Access Compliance Report Public Rights-of-Way (Curb Ramps)

Intersection ID: 4775 Main Street: OLD STATESVILLE RD **Cross Street: HENDERSON_CR** Location: Initial Pass/Fail: Fail **Overall Compliance: No** ADA ID: BAAAA34065F2 Ramp Type: Perp Severity Score: 61.25

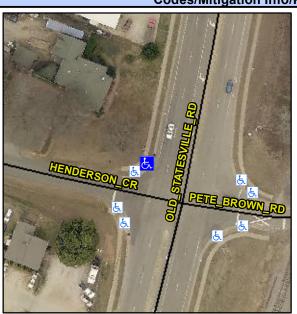
Possible Solutions:
Remove & Replace Entire Ramp.
Surveyor Notes:
N/A
PROW/ADA:
Not Found, R304.5.1, R304.2.2, R304.5.3

Field Measurements/Component Compliance							
Compliance Description		Data	Comp	iance Desc	ription	Data	
N/A	Ramp Length (in)	60.5	No	lo Ramp Slope (%)		14.8	
No	Ramp Width (in)	31.0	No	Ramp XSlope (%)		4.9	
N/A	Flare Type LT	N/A	N/A	Flare Type RT		N/A	
N/A	Flare Slope LT (%)	N/A	N/A	Flare Slope RT (%)		N/A	
N/A	Flare Traversable LT?	N/A	N/A	Flare Traversable RT?		N/A	
N/A	Landing Length (in)	N/A	N/A	DWS Provided?		N/A	
N/A	Landing Width (in)	N/A	N/A	DWS Contrast?		N/A	
N/A	Landing Slope (%)	N/A	N/A	DWS Length (in)		N/A	
N/A	Landing X Slope (%)	N/A	N/A	DWS Full Width?		N/A	
N/A	Landing Curb? (Y/N)	N/A	N/A	DWS Offset (in)		N/A	
N/A	Shared Landing?	N/A					
N/A	Gutter Ponding?	N/A	N/A	Gutter Slope (%)		N/A	
N/A	Gutter Lip Ht (in)	N/A	N/A	Gutter X Slope (%)		N/A	
N/A	Painted X Walk1?	No	N/A	Painted X Walk2?		N/A	
	X Walk 1 Direction	То Е		X Walk 2 Di	rection	N/A	
N/A	X Walk 1 Width (in)	N/A	N/A	X Walk 2 W	idth (in)	N/A
